REFERENCE: **Contract Number Q912PQ-13-P-0079**

SUBJECT: **Final Letter Work Plan Addendum #4 for Modifications to the Existing Air Biosparge Treatment System at Installation Restoration Program Sites 4 and 9, New York Air National Guard, Francis S. Gabreski Airport, Westhampton Beach, New York**

**FIGURE 1
BIOSPARGE SYSTEM
PROTECTIVE MEASURES
SITES 4 AND 9**

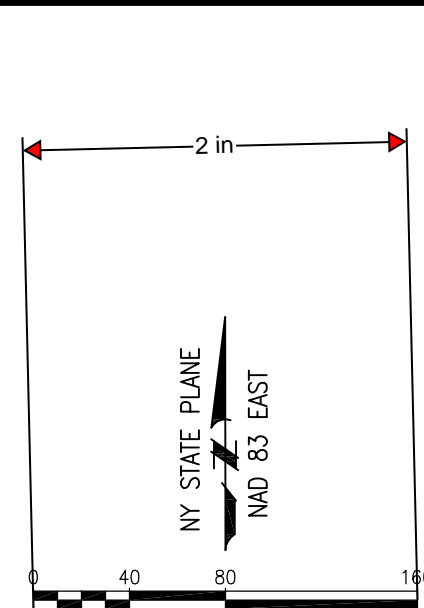
1. Suggest replacing the plume with a more recent one or eliminating it completely from this Figure.
2. Suggest removing Note 1 or at least removing the reference to optimization activities.
3. Suggest adding the tan circle to the table in front of monitoring wells as well as in front of air sparge vaults so that it is clearer.
